GOVERNMENT OF TELANGANA  
ROADS AND BUILDINGS DEPARTMENT

Ltr.No.DB/HD/Banswada-Uppalwai/forest/2021-22 Dt: 11-04-2022.

Sub: Diversion of 2.121 Ha of Forest land for formation approach road construction of HLB across Manjeera River from Dharmareddy to Muddapur via Venkampally road PR road in Kamareddy district in favour of Executive Engineer (R&B) Division Kamareddy -clarifications submission –regarding.

Typical cross of existing road section from km 0/450 to 1/100 (for a length of 750m)

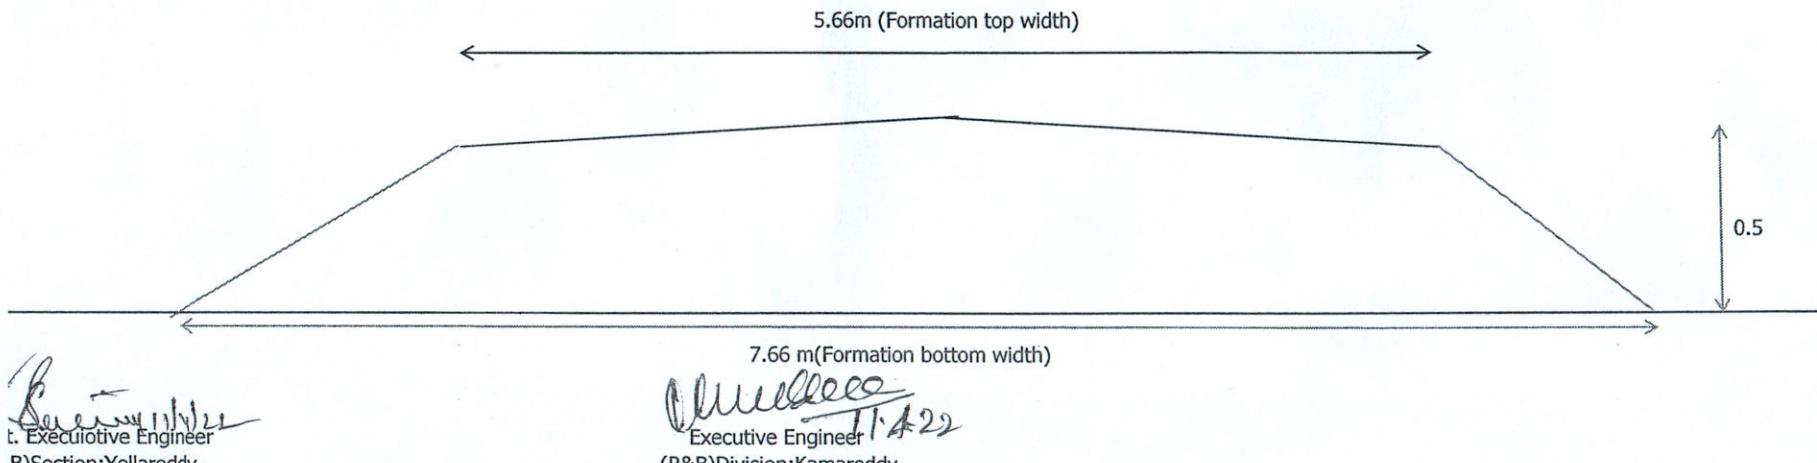
- c) The existing road carriage way width is 3.66m with BT , and 1m shoulders on either side of the road and there are no drains in this portion. (typical cross section is enclosed).
- d) The road in forest are from km 0/450 to 1/100 (750m length) is improvement of existing single lane road, the road from 1/100 to 1/550 (450m length) is new alignment of the road by providing bypass road to Tandoor village. The existing road after Tandoor village is passing over canal bund, the double lane construction activity is not possible over the canal bund. So, alternate alignment is provided from km 1/100 to 1/550. Further, it is inform that, the road from km 1/550 to 5/590 is also new alignment formed by acquiring the private lands, which serves as a approach to newly constructed bridge across Manjeera river. ( Site map is enclosed).
- e) Issue pertains to the Forest Department.
